UNITED STATES PATENT AND TRADEMARK OFFICE

APPLICATION NO.	FILING DATE	FIRST NAMED INVENTOR	ATTORNEY DOCKET NO.	CONFIRMATION NO.
09/766,025	01/19/2001	William R. Voigt	1515.3001.001	7873

Office Action Summary

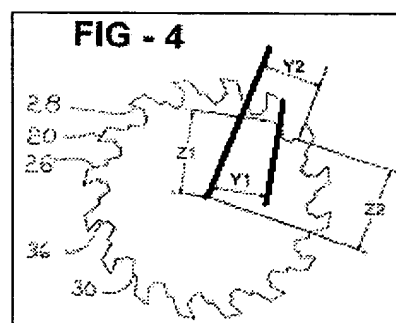
1. The drawings are objected to because figures 4-8 contain text in addition to the figure labels and reference figures. No text should appear on the drawings except for the figure label and the reference characters. Dimensioning marks are acceptable, however, the actual dimensions should be labeled with a reference character and referred to in the specification.

2. The drawings are objected to because the dimension as noted by (Y1) in figures 4-8 is confusing and does not clearly illustrate a particular dimension of the invention. Dimensional markings of this nature generally consist of two parallel lines extending from a defined point on the object of the drawing.

The extensions of (Y1) in figures 4-8 are not parallel and, therefore, it is unclear what dimensions they are actually defining. Please see the figure to the right for an illustration regarding this objection.

The drawings are objected to under 37 CFR 1.83(a). The drawings must show every feature of the invention specified in the claims. Therefore, the “first wall plane [that] intersects the rotor axis” must be shown or the feature(s) canceled from the claim(s). Referring again to figure 4, none of the cross-sectional representations of the rotary cutter illustrate a plane formed by a groove or adjacent wall intersecting the rotor axis. No new matter should be entered.

A proposed drawing correction or corrected drawings are required in reply to the Office action to avoid abandonment of the application. The objection to the drawings will not be held in abeyance.
